Work Order ID 90285

D3290-041 REPLACEMENT WINDOW ASSEMBLY

DRAWING NO. D3290	TITLE REPLACEMENT WINDOW ASSEMBLY	REV. C	DART AEROSPACE LTD ENGINEERING ORDER		D.E.O. NO. D3290-C-1	SHEET NO. SHEET 1 OF 1	SCALE NTS
DRAWN <i>q</i>	CHECKED <i>js</i>	MFG. APPR. <i>E</i>	APPROVED <i>MD</i>		DE APPR. <i>##</i>		
DATE 09.09.18	DATE 09.09.18	DATE 09.09.18	DATE 09/09/21		DATE 09/09/21

CHANGE MATERIAL THICKNESS OF D3290-1 FRAME TO 0.063 FROM 0.040. REF PAR 09-033.

D3290-1 FRAME

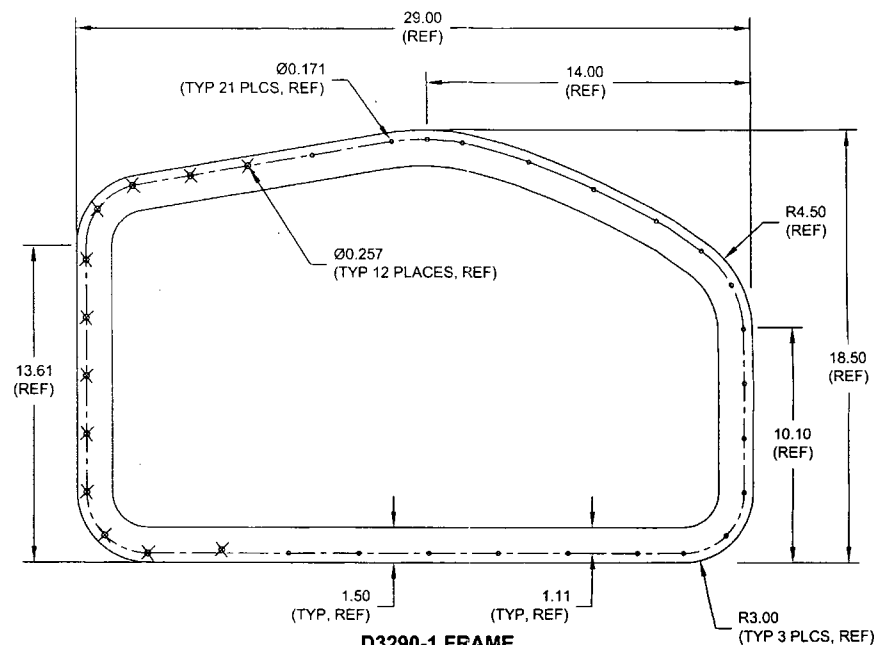
MATERIAL CALL-OUT OF D3290-1 FRAME ON SHEET 1 IS AMENDED AS FOLLOWS:

- 1) MATERIAL: 6061-T6 (OR 6061-T62) ALUMINUM SHEET ~~0.040 THICK~~ 0.063 THICK (REPLACE)
PER AMS-QQ-A-250/11 OR AMS 4025 OR AMS 4027
~~(REF. DART SPEC. M6061T6S.040)~~ REF. DART SPEC. M6061T6S.063 (REPLACE)
OR
5052-H32 ALUMINUM SHEET ~~0.040 THICK~~ 0.063 THICK (REPLACE)
PER AMS-QQ-A-250/8 OR AMS 4016
~~(REF. DART SPEC. M5052H32S.040)~~ REF. DART SPEC. M5052H32S.063 (REPLACE)
